SUBJECT: Savannah River Site's Responses to the Regulatory Comments on the Effectiveness Monitoring Report (EMR) for the P-Area Groundwater (PAGW) Operable Unit (OU) Zero Valent Iron Permeable Reactive Barrier (ZVI-PRB) Removal Action (U) - April 2023 through March 2024 (SRNS-RP-2024-00914, Revision 0, December 2024) SEMS Number: 81

SRS Responses to USEPA Comments on the Effectiveness Monitoring Report (EMR) for the P-Area Groundwater (PAGW) Operable Unit (OU) Zero Valent Iron Permeable Reactive Barrier (ZVI-PRB) Removal Action (U), April 2023 Through March 2024
SEMS Number: 81, SRNS-RP-2024-00914, Revision 0, December 2024,
Savannah River Site, Aiken, South Carolina

Figure CR-1. Cross-Section of the Zero-Valent Iron Permeable Reactive Barrier with TCE Soil Concentrations

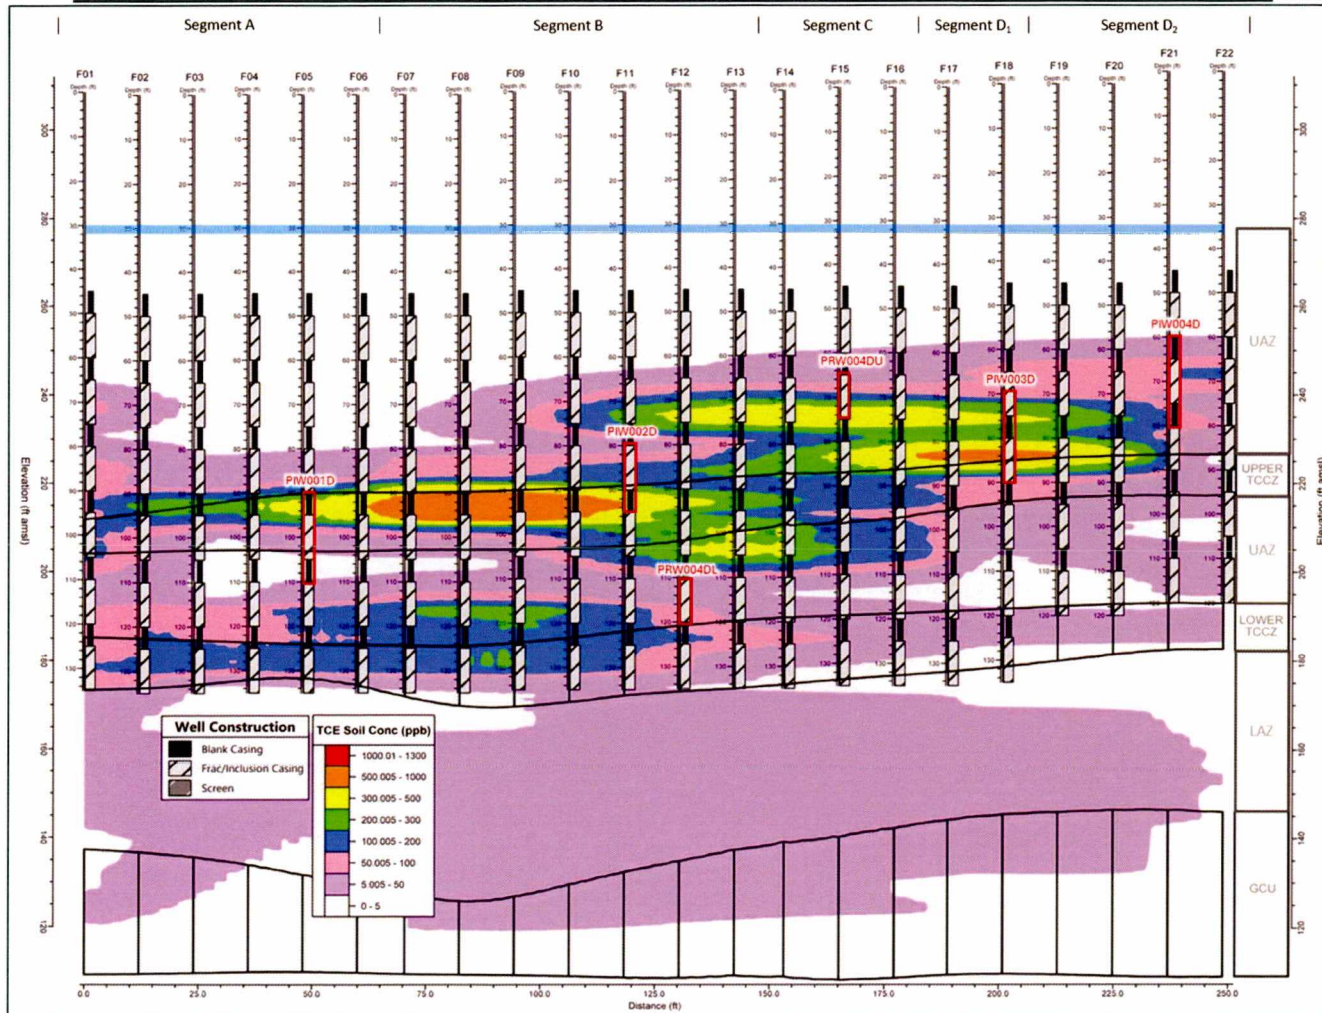
1. It is unclear if additional characterization is warranted to determine whether groundwater may be bypassing the zero-valent iron (ZVI) permeable reactive barrier (PRB). It is noted that the observed volatile organic compound (VOC) concentrations, trends and groundwater chemistry at the PRW004 and the PRW007 well clusters may indicate bypass of the ZVI-PRB is occurring. Specifically:

- a. PRW004DL and PRW004DU are located immediately downgradient of the ZVI-PRB, and first quarter 2024 (1Q24) concentrations of trichloroethene (TCE) are elevated above the maximum contaminant level (MCL) of 5 micrograms per liter ($\mu\text{g/L}$) at 101 $\mu\text{g/L}$ and 10.4 $\mu\text{g/L}$, respectively. The TCE concentrations in PRW004DL and PRW004DU have been increasing since 2022 (see Figure 12, Time-Series Plot for TCE at UAZ Monitoring Well Clusters for P002U, PW002 and PRW004). The EMR indicates that the elevated and rebounding concentrations observed at the PRW004 well cluster are likely due to back diffusion from low-permeability sediments downgradient of the ZVI-PRB, however, it is also possible that slow groundwater velocities or preferential flow paths may be contributing to incomplete treatment or localized bypass of the ZVI-PRB.

- b. The PRW007 well cluster is located on the downgradient of the ZVI-PRB. Appendix A (PAGW OU RA EMR Analytical Data 2023-2024) indicates total iron remained below the method detection limit (MDL) at PRW007DL and ranged between 320 and 1790 micrograms per liter ($\mu\text{g/L}$) at PRW007DU, and oxidation-reduction potential (ORP) ranged between 84.7 and 346 millivolts (mV) at the PRW007 well cluster, suggesting that the reducing environment is not strongly ZVI-influenced. This geochemical combination is not the same fingerprint as other downgradient well clusters (i.e., PRW002 and PRW004) which had total iron ranging between 2580 and 21,600 $\mu\text{g/L}$ and ORP ranging between -284 and 59.2. As water passes through the ZVI, iron corrodes and additional Fe^{2+} (ferrous iron) is produced in groundwater. So, elevated total iron is expected downgradient of the ZVI-PRB and a greater reducing environment is expected. As such, it is unclear whether there is evidence, based on the geochemical fingerprint at the PRW007 well cluster, that groundwater is bypassing the southern end of the ZVI-PRB and the bypass is contributing to the VOC concentrations and groundwater chemistry noted at the PRW007 well cluster.

To differentiate between back diffusion and potential bypass, additional characterization actions, such as conducting tracer tests to confirm flow paths or installation of an additional monitoring well on the southern side of the ZVI-PRB, could be performed to verify ZVI-PRB performance. Please revise the EMR to discuss whether additional characterization is needed to demonstrate that bypass is not occurring.

Soil sampling completed during the Pre-Design Investigation for the ZVI-PRB demonstrated the majority of TCE mass is entrained in low permeability sediments of the upper aquifer zone and in the tan clay confining zone. PRW004DU and PRW004DL are located immediately downgradient of high soil concentrations in the upper tan clay confining zone based on this data (Figure CR-1). In-wall monitoring wells are screened in the transmissive zones of the upper aquifer zone and partially in the upper tan clay confining zone, where the highest soil concentrations were observed. The in-wall monitoring wells consistently demonstrate near complete degradation of TCE in groundwater, within the low-permeability sediments and high TCE soil concentrations. The ZVI-PRB is not mobile and does not come in contact with TCE in the soil. Therefore, it is expected that TCE mass will preferentially diffuse into the clean groundwater front leaving the ZVI-PRB due to the reversed concentration gradient created. Back-diffusion of TCE mass entrained in the low-permeability sediments is still believed to be a major factor contributing to the detected TCE concentrations at monitoring wells immediately downgradient of the ZVI-PRB, however it is possible there are other contributing factors such as preferential flow paths through the barrier (decreased residence time), discontinuous sections of the ZVI-PRB (no contact with ZVI), or localized bypass to the south or below the barrier. SRS has considered this potential and is planning for actions to investigate this in 2026. Two planned actions are to install transducers in stations within the ZVI-PRB monitoring well network to collect high frequency water level data and assess the groundwater flow direction and potential mounding upgradient of the ZVI-PRB. The second plan is to complete hydraulic pulse interference testing (HPIT) to compare with HPIT done pre-construction of the ZVI-PRB and immediately following construction. These tests will provide some insight into the permeability of the barrier since completion of construction activities and identify if additional testing is warranted. Details of the test plans and reporting plans will be described in the 2025 EMR report.

No change to the 2024 EMR report is proposed.

Figure CR-2. Time Series Plot for Trichloroethylene (TCE) at Monitoring Well PIW003D

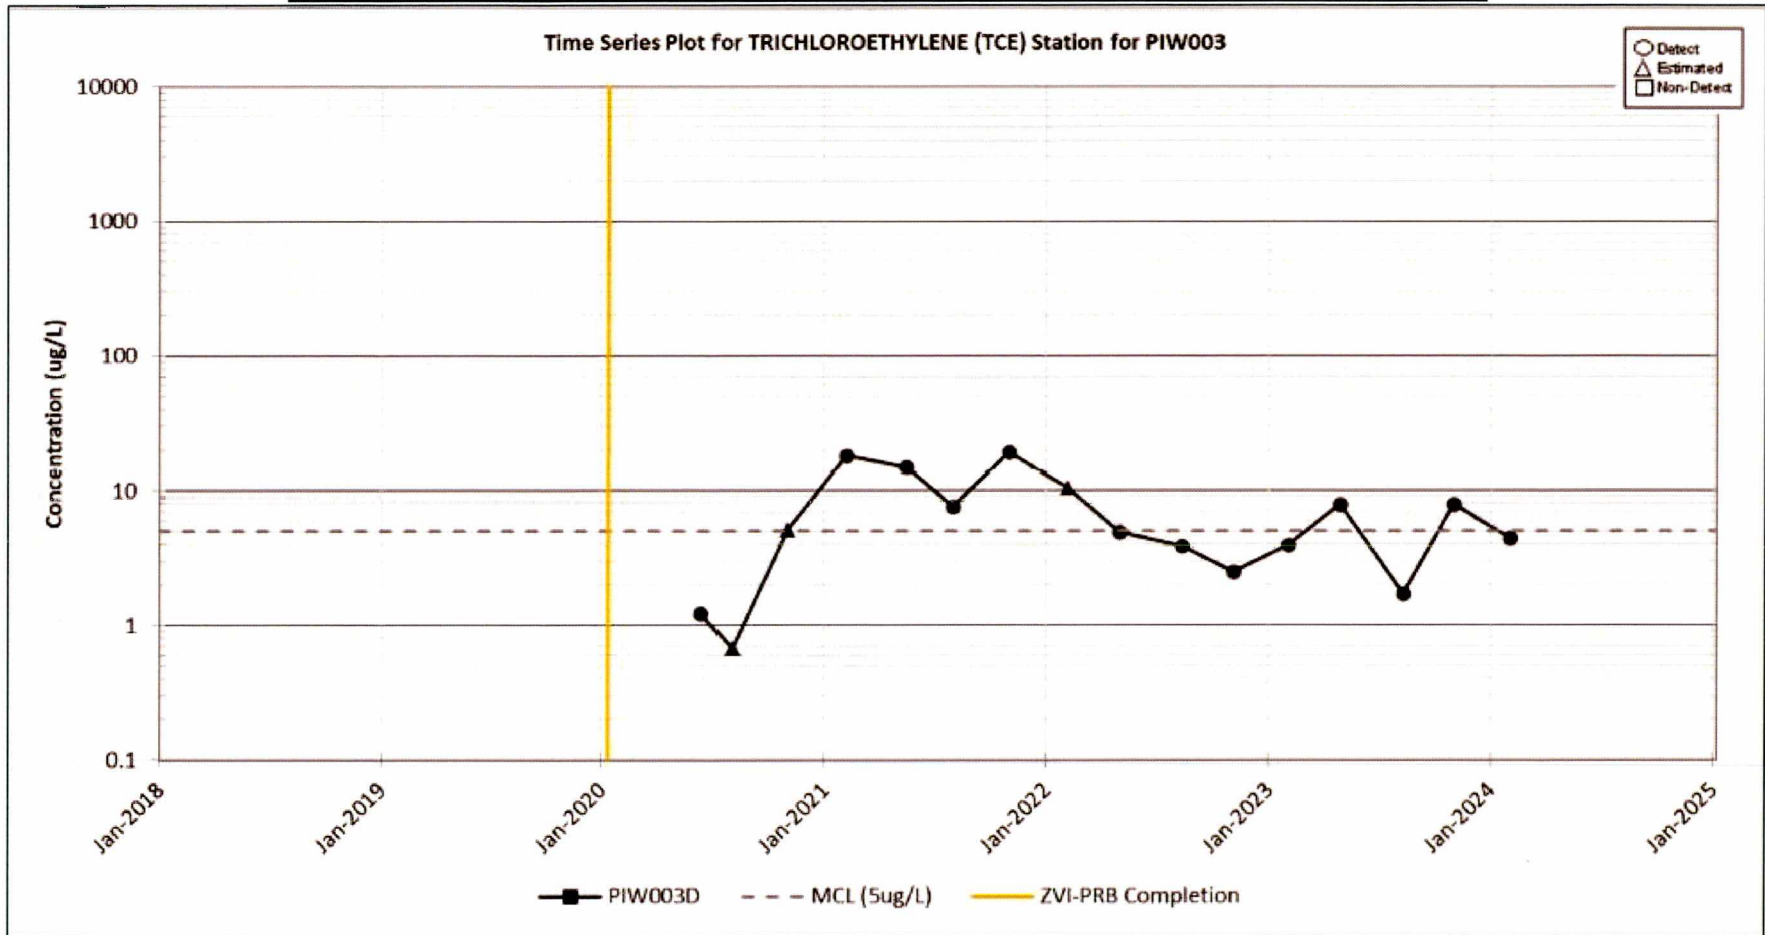
1. **Section 2.4, Removal Action Implementation and Monitoring Goals, Page 7 of 58:** The text states, “The implemented ZVI-PRB is anticipated to reduce the mass flux of TCE through the neck area of the PAGW [P-Area Groundwater] OU [operable unit] TCE plume by at least 80% [percent] in order to meet the RAO [remedial action objective];” however, the text does not discuss the estimated timeline for reaching the 80% reduction. *For clarity, please revise the EMR to discuss the RAO timeline and whether the results are within the estimated time ranges for achieving the RAO.*

The removal action objective (RAO) for the non-time critical removal action is to reduce TCE mass in the groundwater plumes so that the mass flux to Steel Creek will be reduced to reach the maximum contaminant level in Steel Creek. In the Removal Site Evaluation Report (RSER)/Engineering Evaluation (EE)/Cost Analysis (CA) for this non-time critical removal action, it was assumed that a reduction of groundwater plume mass flux across the treatment zone of greater than 80% would be sufficient to meet the RAO (SRNS 2018). The ZVI-PRB was designed to exceed this reduction in the design objective (>90%) and in the safety factor applied to the design thickness in the Removal Action Design Plan (RADP) (SRNS 2019). A timeline to achieve this RAO was not proposed in the RSER/EE/CA or in the RADP, however five years of monitoring was proposed. The 2025 EMR report will be the fifth and final planned EMR for the non-time critical removal action. SRS intends to discuss the performance of the ZVI-PRB in relation to the RAO in this final EMR. Additionally, Savannah River National Laboratory is performing an independent review of the ZVI-PRB performance after five years of monitoring to supplement the final report by SRS.
